# CITY OF HALLOWELL

## Historic District Certificate of Appropriateness Application

Property Address: 117 Second St. Zone: \_\_\_\_\_

RE. Proposed work to 117 Second Street Porch and Barn.

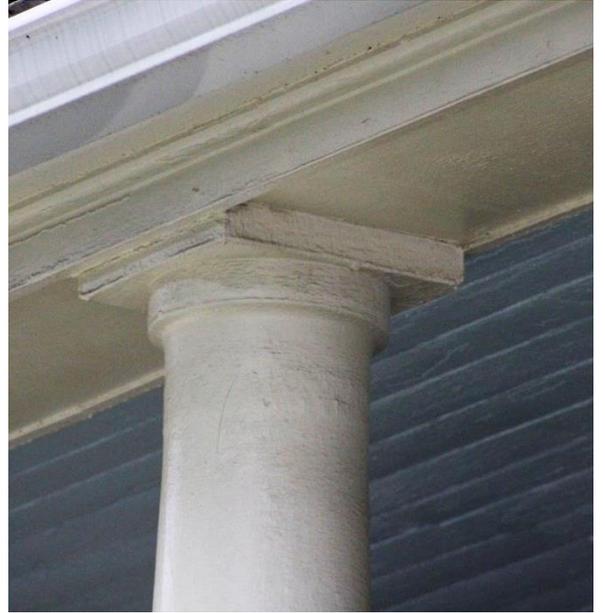
The most concerning issue I saw in terms of meeting the standards was that the proposed column capitals were not a good match to the existing, which are unusually simple. The column bases have been replaced in the past, probably when the knee wall was added to the porch and one end was infilled with window sash.

- The column spacing needs to match the existing even though it is not regular. As I explained to the contractor, from a preservation perspective, the existing spacing of the columns is not wrong. It is authentic. Making them more evenly spaced than they were historically would not be appropriate.

- The existing knee wall and glass-enclosure of one section of the porch are clearly later alterations and their removal is allowable under the standards.

- The existing column bases appear to have been installed as replacements for original bases, probably when the knee wall was installed. The existing bases were likely not there and consequently never visible when the columns were fully exposed and replacing them with a simple and compatible Tuscan base is appropriate.

Proposed Column Design

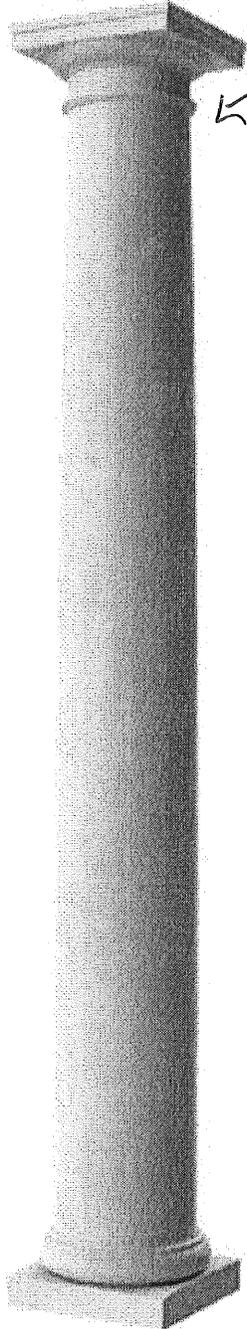
The manufacturer for the columns and caps recommended by the contractor does not make a column without a projecting astragal ring several inches below the capital. I called and spoke with their customer service department to confirm this. They cannot remove the rings from the cast columns. Other manufacturers are able to remove the ring from their columns. This is an important detail because we already have to propose a capital that is not a close match to the existing. If the column also does not match, having a detail that gives it a level of style the original column doesn't have, it becomes questionable whether this meets the standards. I explained to the contractor the importance of not making the new work noticeably "better" than the historic work – the goal of preservation being to preserve the actual past, not a "better" version of it.

So, I looked for how close we can get to the dimensional details and general character of the historic capitals and columns with other available options. Most column manufacturers offer a simple Tuscan capital that is probably as close as we can get to the existing capitals. Tuscan capitals are simple and the simpler the better for this element on this house. It will be somewhat more stylish than what is there now, but not by a great degree.

# Tuscan Capital

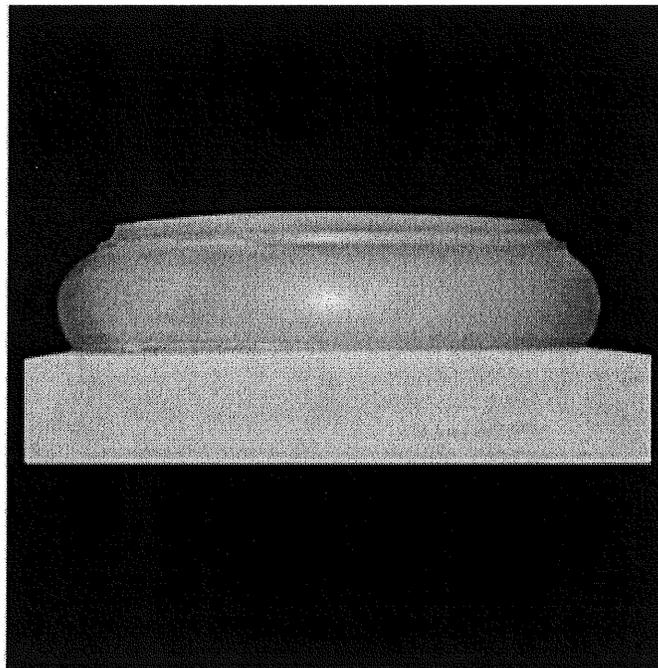
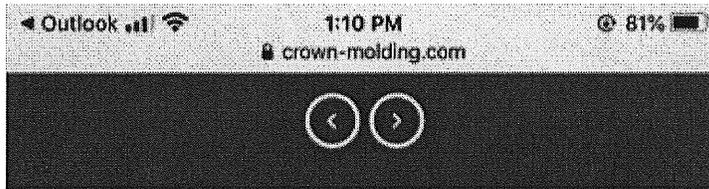
This capital from Royal Corinthian is a simple Tuscan design: <https://crown-molding.com/product/tuscan-capitals-fiberglass-various-sizes/>

This company told me they can remove the astragal ring from any of their columns. Their Tuscan base is also simple in design and probably similar to what your columns originally had based on the simplicity of the surviving capitals: <https://crown-molding.com/product/tuscan-base-fiberglass-various-sizes/>.

I believe this column, base, and capital, whether from this company or another, will meet the standards for this project. Although not an exact match for the existing, the house sits some distance from the street and the difference should not be noticeable to most people from the sidewalk.

# Garage Door

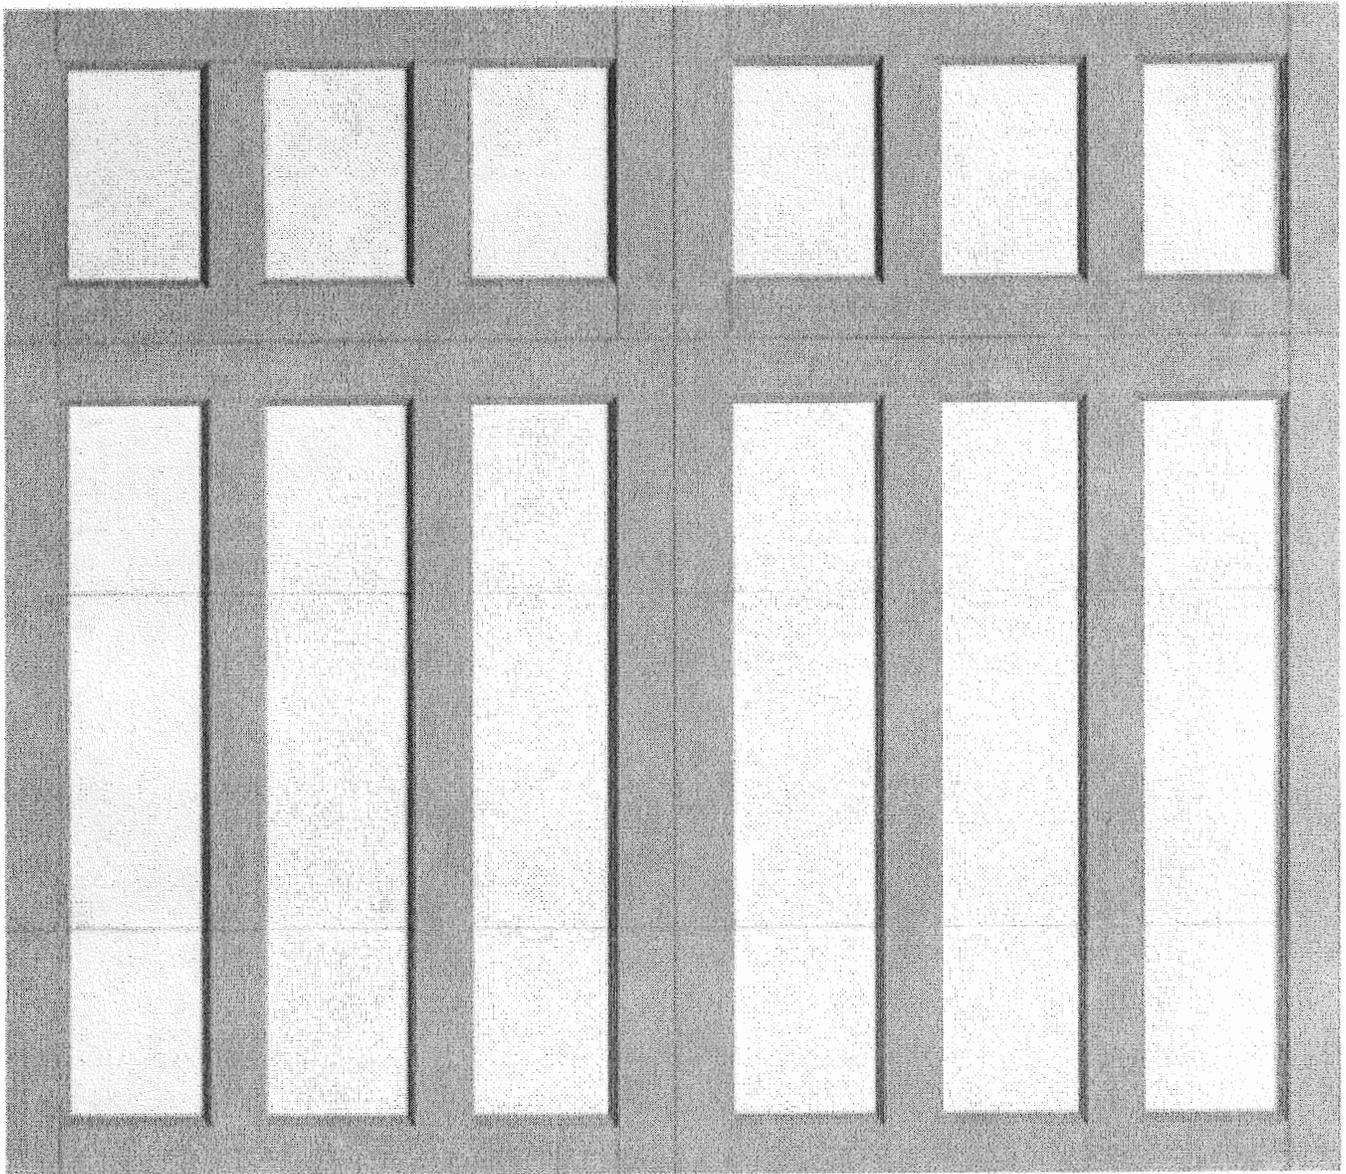
- That the proposal to increase the size of the barn door a modest amount does not present any issues regarding the standards. The replacement trim should be as simple as the existing trim and the door should be a solid traditional carriage house style door.

- That the severely deteriorated window in the same elevation of the barn should be replaced by a closely matching wood double-hung window. Since it is unheated and unused space, a single-paned Boston style window from Brosco would probably be the least expensive appropriate option. It is also possible to just buy the sash and leave the frame if the sizes of the existing match one of their available sizes (of which there are many).
